Well Name: WEST BISTI 26-12-5 COM	Well Location: T26N / R12W / SEC 5 / NESW / 36.51619 / -108.136993	County or Parish/State: SAN JUAN / NM
Well Number: 2	Type of Well: OTHER	Allottee or Tribe Name:
Lease Number: NMSF081102A	Unit or CA Name: WEST BISTI 26-12-5	Unit or CA Number: NMNM94028
US Well Number: 300452915100S1	Operator: DUGAN PRODUCTION CORPORATION

Type of Submission: Notice of Intent	Type of Action: Plug and Abandonment
Date Sundry Submitted: 07/13/2025	Time Sundry Submitted: 03:55
Date proposed operation will begin: 07/18/2025

### Notice of Intent – Plug and Abandonment

**Operator:** Dugan Production Corporation  
**Lease:** NMSF081102A  
**Agreement:** NMNM94028  
**Well(s):** West Bisti 26-12-5 Com 2, US Well # 30-045-29151  
**Location:** NESW Sec 5 T26N R12W (San Juan County, NM)  
**Sundry Notice ID #:** 2862935

**Planned P & A Wellbore Schematic**

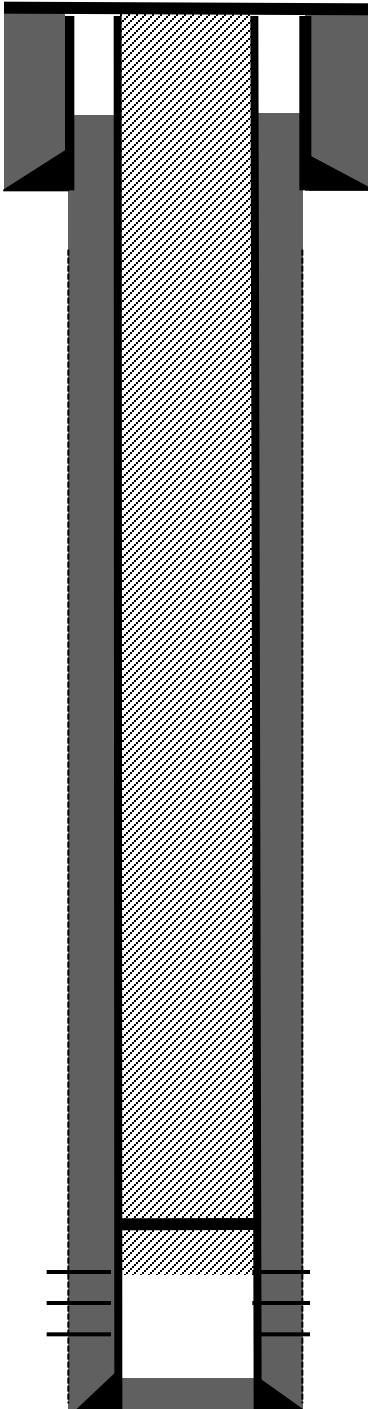
1. Plugging operations authorized are subject to the attached "General Requirements for Permanent Abandonment of Wells on Federal and Indian Lease."
2. The following modifications to your plugging program are to be made:
  - a. Complete wellbore fill up proposal. No changes to procedure.
3. **Notification:** Farmington Office is to be notified at least 24 hours before the plugging operations commence at (505) 564 7750.

Complete wellbore fill up proposal. No changes to procedure. Limited raster log data associated to the well. Reference well supports the formation tops selected by the operator.
